## Administrative Action Preliminary Subdivision

**Case File / Name:** S-30-12/ Fairfax Hills Park Subdivision

**Nature of Case:** For the subdivision of a 3.54 acre tract zoned R-4 into 4 lots. The proposed subdivision is not an infill since the lots are greater than 80% of the median lots size and linear frontage of the peripheral tracts.

**OFFICIAL ACTION: Approval with conditions**

### Proposed Subdivision

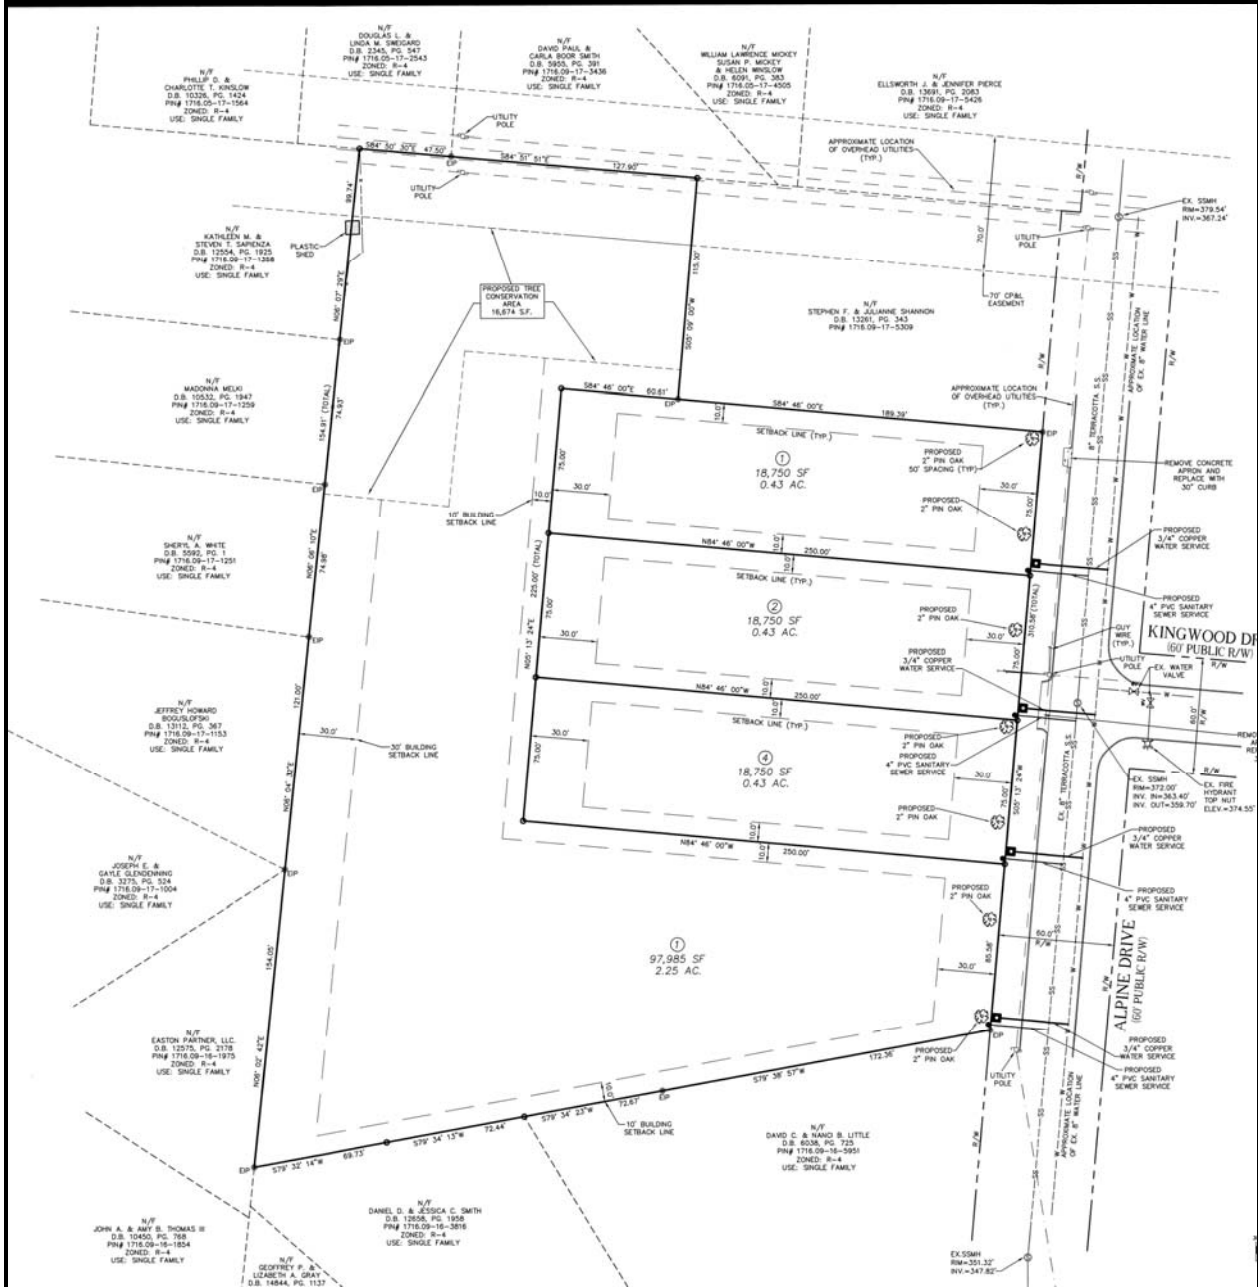
In reviewing the application, staff has identified the following policy guidance not reflected on the site plan:

T 5.5 Sidewalk requirements: The policy states that new subdivisions should provide sidewalks on both sides of the street. The application would be compliant with this policy if sidewalks were proposed along the Alpine Drive right-of-way.

LU 8.10 Infill Development: This policy encourages infill development to complement the established character of an area. UD 5.1 Contextual Design and UD 5.4 Neighborhood Character and Identity policies call for new development to enhance the surrounding area, and relate to the scale of the existing neighborhood context. The house on the adjoining parcel is two-story; most nearby are one-story. Brick is a prominent building material. Lots are characterized by canopy of established trees. To comply with the cited policies, you are encouraged to consider such design precedents.

**CONDITIONS OF APPROVAL:** *Prior to issuance of any grading permit for the site:*

- (1) That prior to the issuance of a grading permit, the final tree conservation plan must be approved by the Forestry Specialist in the Planning Department. The plan must show metes and bounds descriptions of all tree conservation areas, and tree protection fence around all tree conservation areas. Tree protection fence must be located in the field and inspected by the Inspections Department. A copy of the approved plan is placed on file in the Planning Department;
- (2) That a demolition permit be issued; and the demo permit number is shown on the recorded map;

- (3) That a plat with metes and bounds descriptions of all tree conservation areas, areas labeled with Standardized Names and outlined in dashed lines must be submitted to Development Services. The plat must be reviewed then recorded with the Wake County Register of Deeds. A copy of the recorded Tree Conservation plat should be submitted with the building plans.
- (4) That a fee-in-lieu of construction for ½ 5' sidewalk along Alpine Dr. be paid to the Public Works Department;
- (5) That the demolition permit number is placed on the plat if the structures have not been removed from the site and the demolition permit has not been finalized;
- (6) That the impervious surface limitations for the lots are recoded as follows:
  - Lot 1 8,000 sf
  - Lot 2 8,000 s.f.
  - Lot 3 8,000 sf
  - Lot 4 8,900 sf
